RECALL AND REPLACEMENT NOTICE

8 POST CONTACTORS FOUND IN WARN® ATV WINCH KITS

(WARN Part Number 62135.A0)

SOLD BETWEEN MAY, 2001 AND SEPTEMBER 1, 2005

RECALLED: 8 POST CONTACTOR

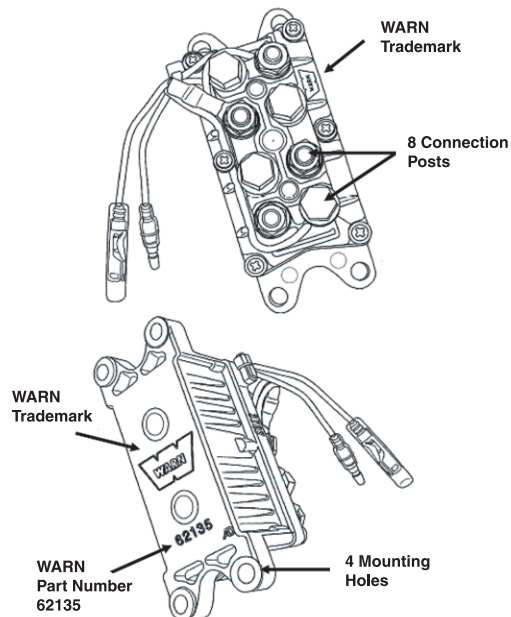
WARN received one confirmed report of an 8 post contactor failure that resulted in excessive heat within the contactor. Under rare circumstances, the contactor could potentially create a fire hazard.

- 8 connection posts on top
- WARN® trademark on top and bottom
- 4 mounting holes on bottom

REMOVE, DISCARD AND REPLACE
WARN PART NUMBER 62135
A0 Revision

Consumers who have WARN ATV winches with 8 post contactors should immediately disconnect the contactor wires from their ATV battery, and call their local ATV dealer or WARN to receive a free replacement contactor and installation instructions. Consumers can call WARN toll-free at **866-408-3767** weekdays between 7 and 4 PST, or by e-mail at contact@warn.com, or visit www.warn.com.

NOT RECALLED: 4 POST CONTACTOR

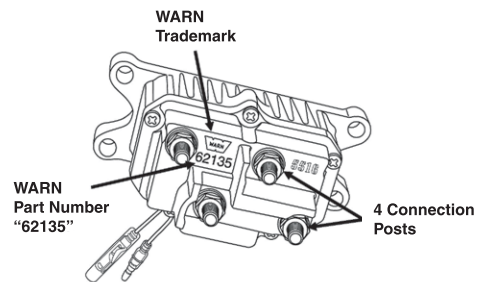
WARN PART NUMBER 62135
C0 Revision

To order a FREE replacement 4 post contactor call WARN toll-free at 866-408-3767 weekdays between 7 and 4 PST, or by e-mail at contact@warn.com, or visit www.warn.com.

8 POST CONTACTOR DISCONNECT INSTRUCTIONS

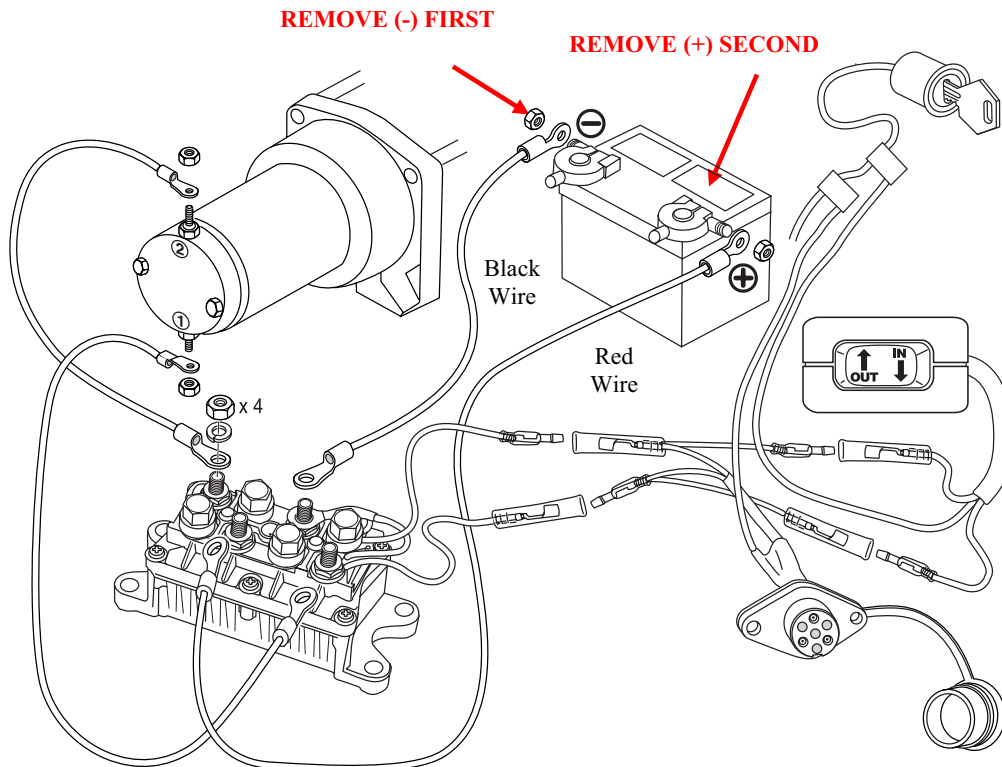
1. Confirm ATV/UTV is equipped with WARN ATV winch with a capacity of 2,500 to 3,500 lbs.
2. Locate Contactor. Removal of seat or some vehicle components may be required to locate contactor. If required, trace wires from winch motor to contactor.
3. Confirm contactor is a WARN 8 post style contactor and subject to recall as identified on the opposite side of this notice.

NOTE: Identifying features: 8 Connection Posts – WARN trademark – 4 mounting holes.

STEP II. Disconnect contactor power wires from vehicle battery. (-) First (+) Second

1. Locate vehicle battery. Verify location with owners manual, if needed.
2. Disconnect all wires attached to the negative battery terminal. Temporarily secure and label wires away from battery.
3. Disconnect all wires attached to the positive battery terminal. Temporarily secure and label wires away from battery.
4. Identify and trace red and black winch electrical cables from contactor back to battery location.
5. Insulate battery end of red and black winch electrical cables with electrical tape.
6. Separately secure the red and black winch electrical cables away from battery with electrical tape or tie-wrap.
7. Reconnect all remaining positive wires to the positive battery terminal.
8. Reconnect all remaining negative wires to the negative battery terminal.
9. Reinstall seat or other vehicle components, as necessary.
